Transmittal
Submittal Review Response

Re: **Project No.:** 253117-261237
Project Name: PSTA Clearwater Multimodal Transit Center
Client: Pinellas Suncoast Transit Authority

Submittal No.: **S-051200-002-F**
Title or Description: **Structural Steel Framing Canopy & Pavilion**
Type of Submittal: **Shop Drawing** **If other**
Status
Review Code: Code 4: Approved As Noted; Resubmit
Other:
Review Comments:

S-051200-002-F - Structural Steel Framing Canopy & Pavilion

1 E103 ELEVATION VIEW
(REF: 3/S-PB-3)
(OTHERS NOT SHOWN FOR CLARITY)

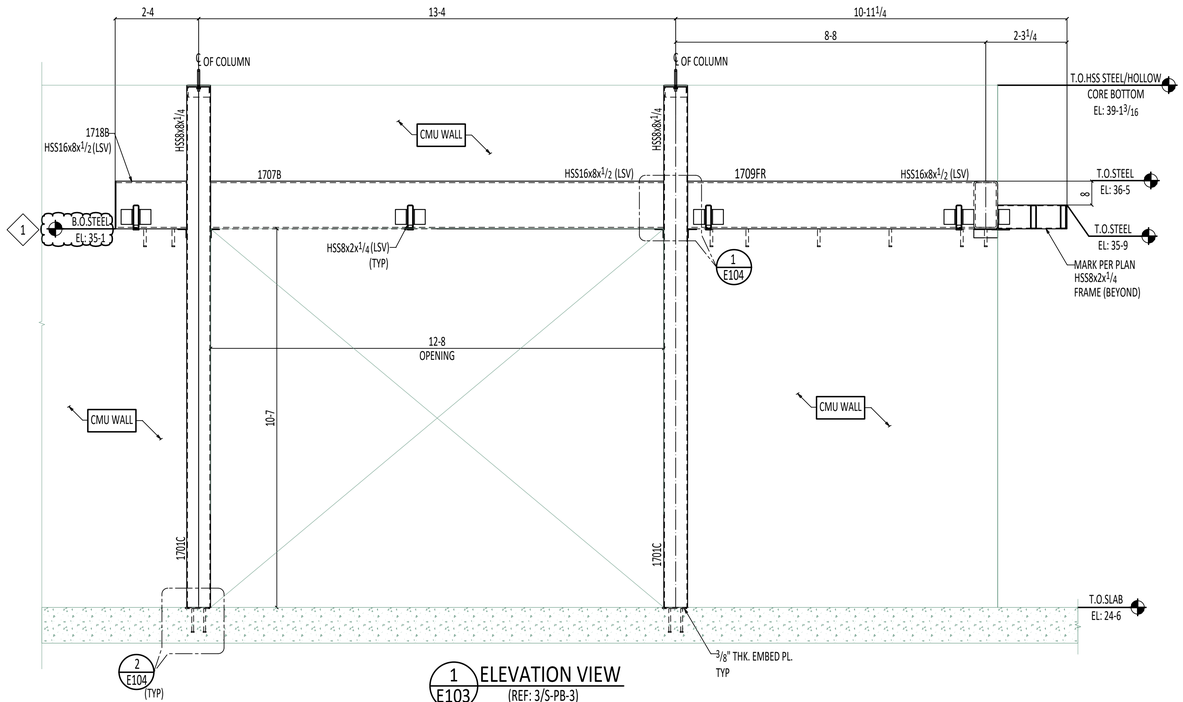
4. Contractor to confirm steel elevation on p. 6 of 231 with approved storefront (not yet submitted). Engineer confirms intent is met. This is a repeat comment and Contractor has indicated coordination to still be completed.

1 -GC TO CONFIRM THE BOTTOM OF STEEL ELEVATION WITH STOREFRONT & CONCRETE CURB MANUFACTURER.

24. Storefront steel elevation
EOR previously confirmed design intent. Final bottom-of-steel elevation will be coordinated with storefront and curb manufacturer information before affected fabrication.

SHOP BILL	WORK ORDER NO.	DRWG. NO.
	2553	E104

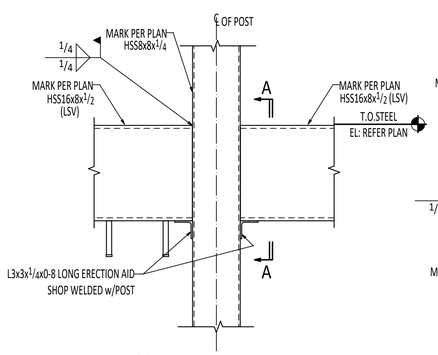
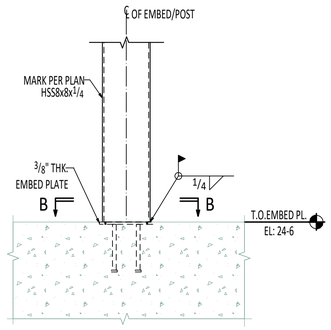
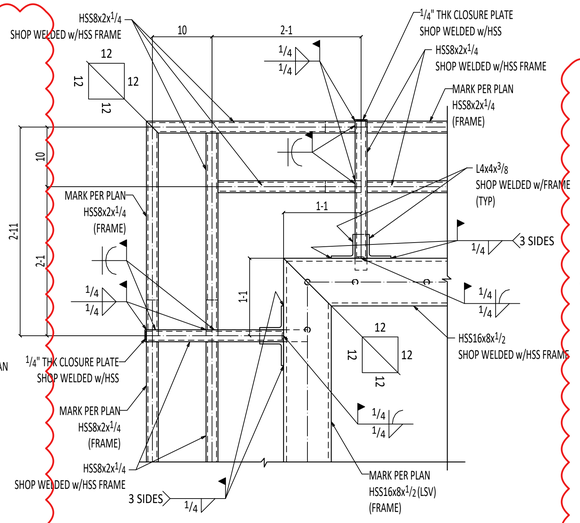
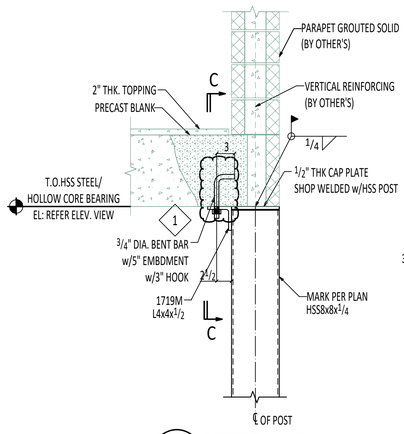
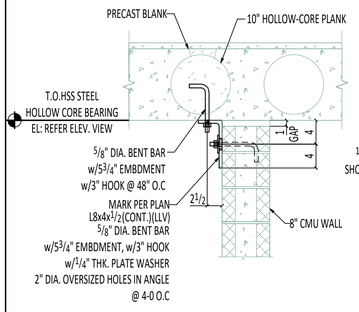
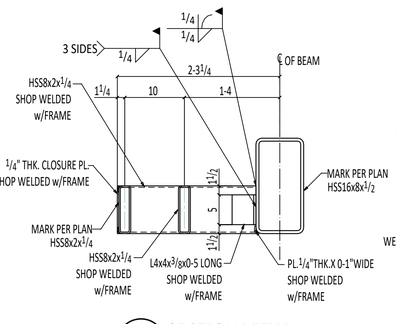
11. At Waiting Pavilion building, Contractor to coordinate with the selected transformer manufacturer to confirm the location of the transformer support beams, and transformer connection requirements. This is a repeat comment as Contractor has indicated to be coordinated. Contractor to confirm intent if planned to be coordinated in field, will require coordination with grouted/reinforced CMU.

1. - PLEASE VERIFY AND CONFIRM THE TOP OF BEAM ELEVATION WITH FINAL APPROVED TRANSFORMER COORDINATION DRAWINGS.
   Contractor to coordinate with the selected transformer manufacturer
2. IF WE MAINTAIN A 1 1/2" EDGE DISTANCE, THE RESULTING HOLE C/C DIMENSION WILL BE 5 1/4", AS SHOWN. PLEASE CONFIRM WHETHER THIS IS ACCEPTABLE.
   It is acceptable
3. IF WE FOLLOW 4" BOLT SPACING PER CD, THNE THE ANGLE WILL CLASH WITH BEAM K VALUE. HENCE WE FOLLOWED 3" SPACING. PLEASE CONFIRM WHETHER THIS IS ACCEPTABLE.
   If 4" spacing is maintained, there will be a slight clash with the beam root radius which should be fine. But the bolt spacing can be reduced to 3 1/2" to avoid the conflict with the root radius.
4. AS PER STANDARD PRACTICE, WE HAVE USED 3/4" DIA. BOLTS INSTEAD OF THE 5/8" DIA. BOLTS SHOWN IN THE CD. PLEASE CONFIRM WHETHER THIS IS ACCEPTABLE.
   It is acceptable

4. Waiting Pavilion transformer supports
W8x24 supports and anchorage are shown. Final location/elevation will be coordinated with the selected transformer manufacturer. Morrow's revised bolt arrangement is submitted for EOR review; follow-up will be submitted if required.

SHOP BILL	WORK ORDER NO.	DRWG. NO.
	2553	E106

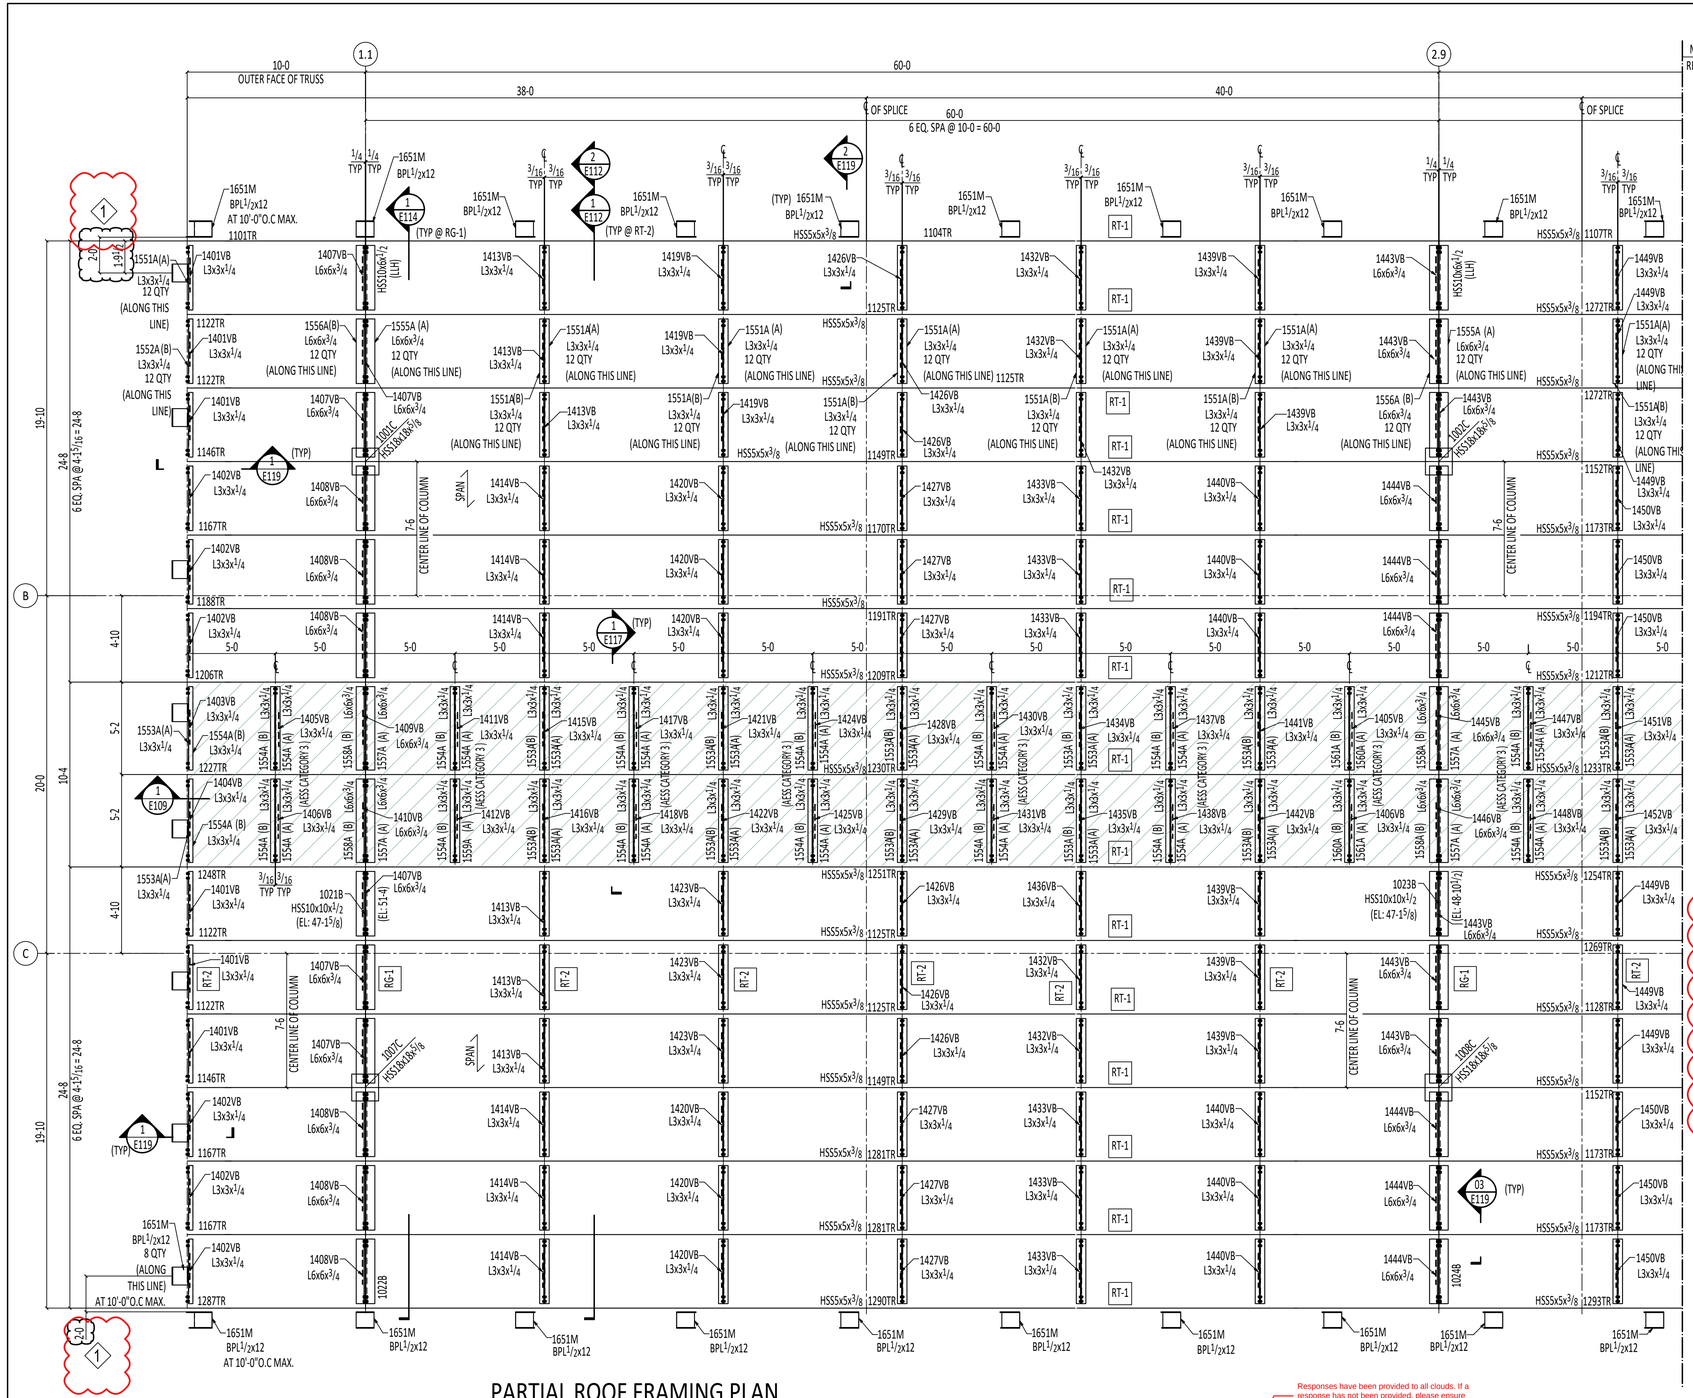
28. Receipt acknowledge od drawing E121 Wave Canopy roof hatch. However, hatch location is not shown on E106 partial roof framing of wave canopy. Contractor to locate and properly adjust roof hatch on E106.

Responses have been provided to all clouds. If a response has not been provided, please ensure Engineer is aware to respond to.

29. Wave-canopy roof hatch
Wave-canopy roof opening/hatch framing is included on E121.

1 E110 ROOF TRUSS ELEVATION VIEW-1 (RT-1)

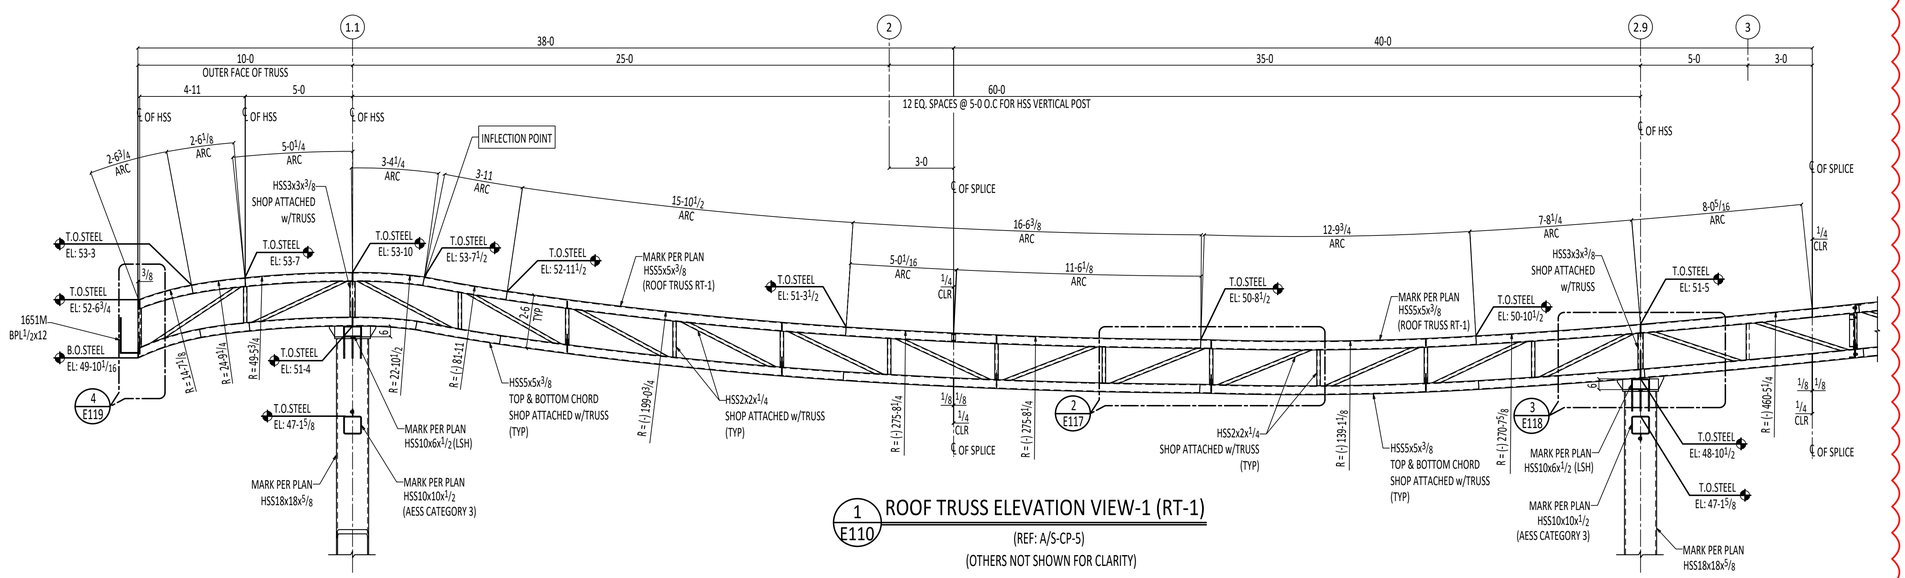
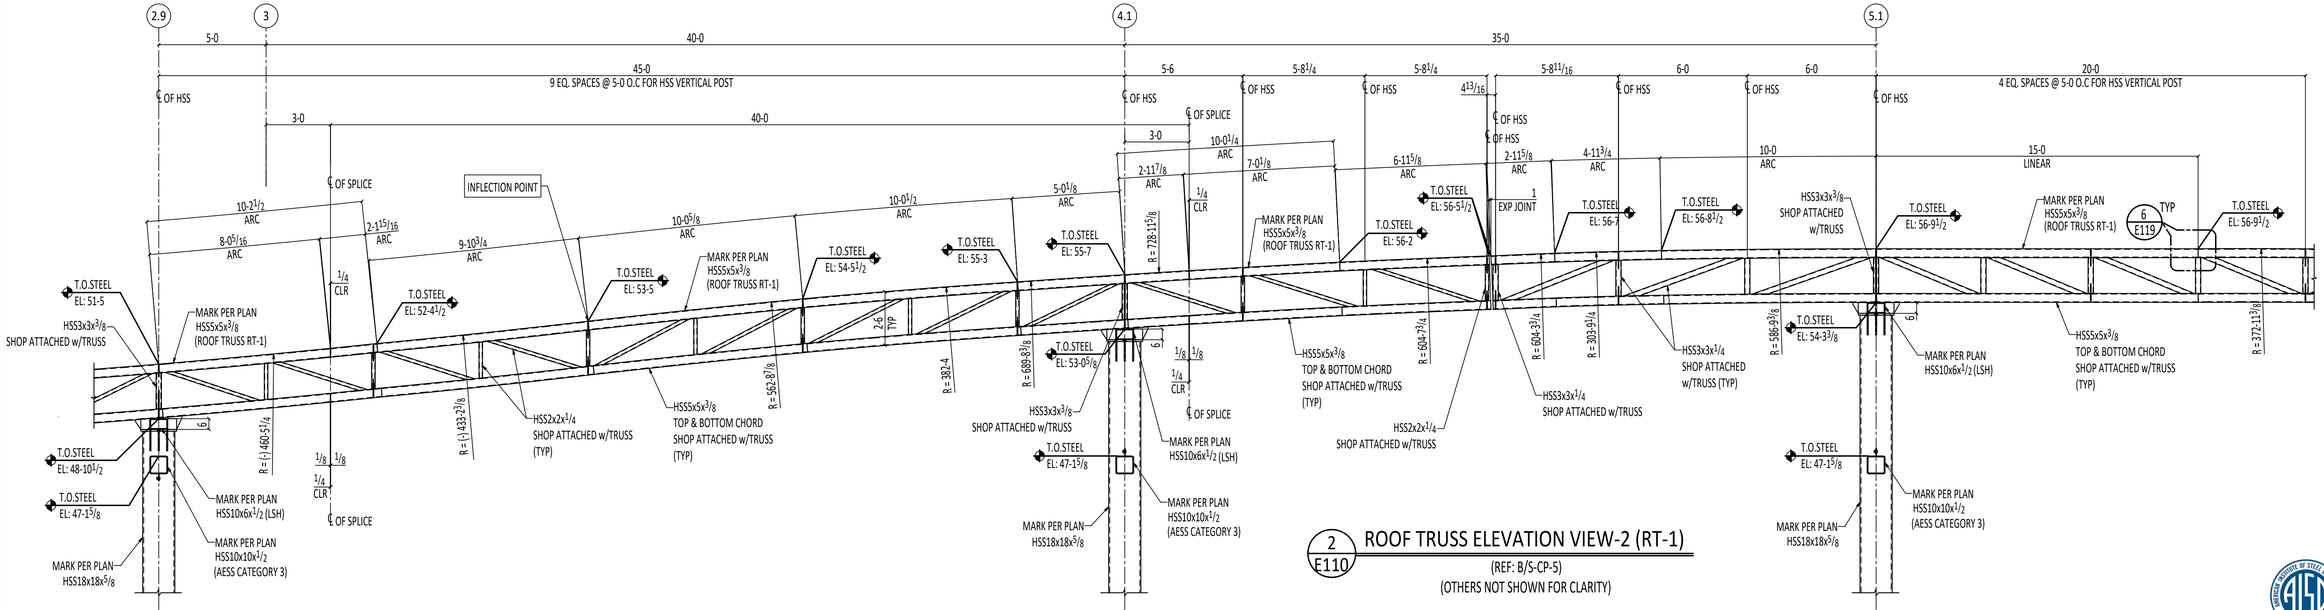
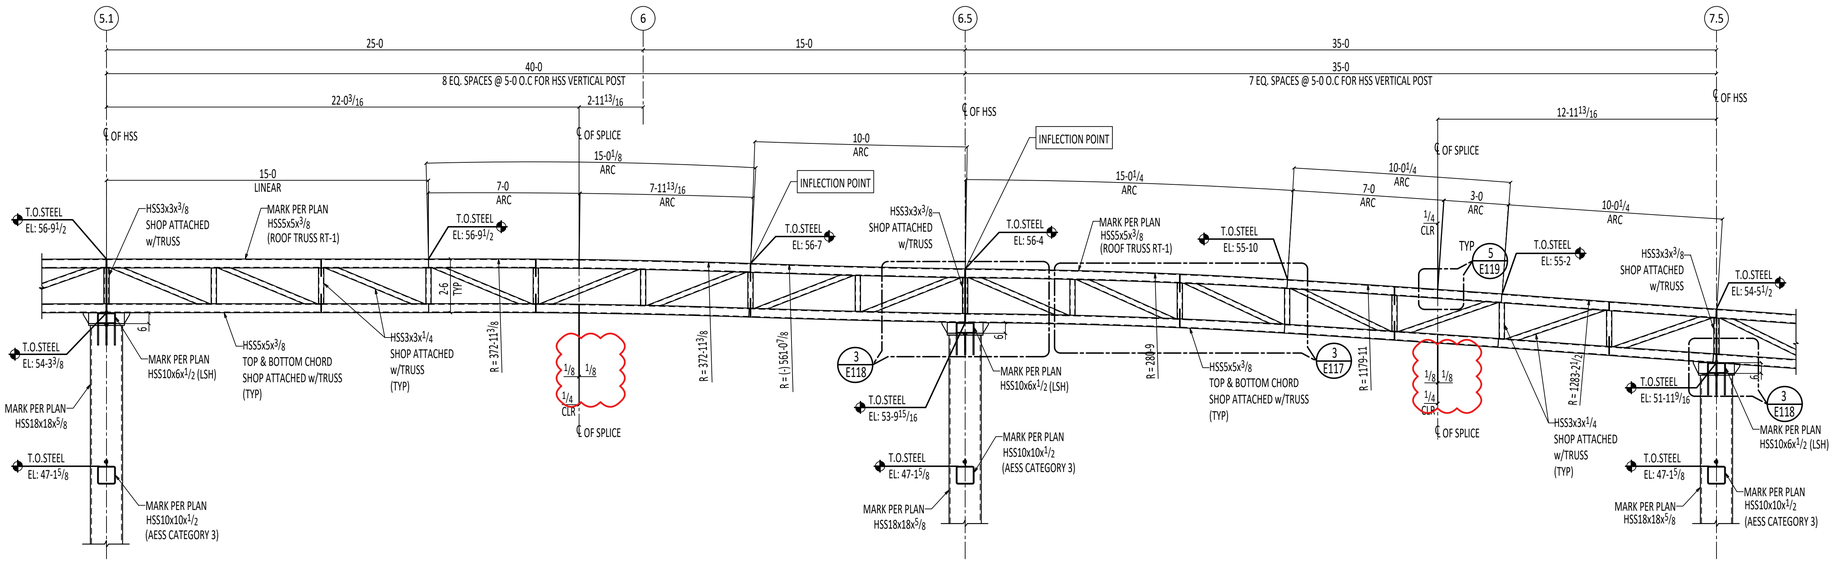
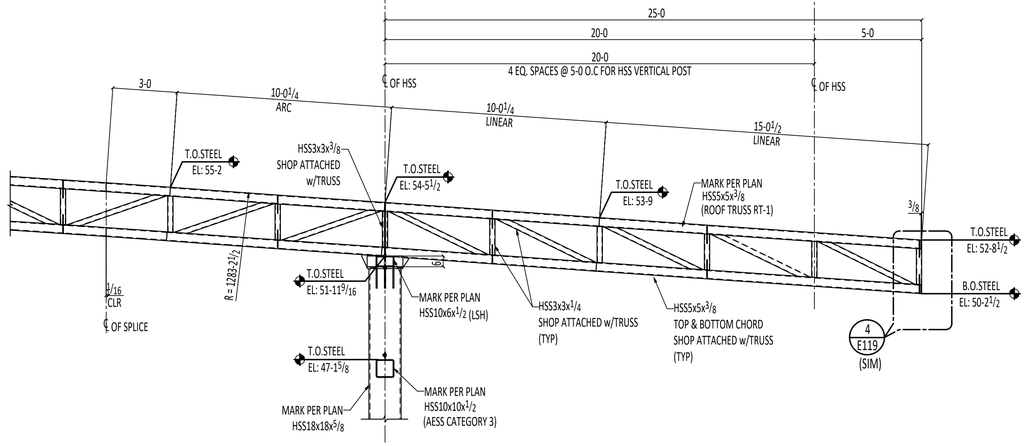
5. There is a mismatch between the dimensions and wave truss bend radii shown on the overall truss longitudinal drawings, E110 and E111, and those shown on the contract drawings and typical truss shop drawings, Drawing Nos. 1176 through 1200. Coordinate between the drawings and ensure that

all dimensions and bend radii are consistent with and accurately reflect the requirements shown on the contract drawings.
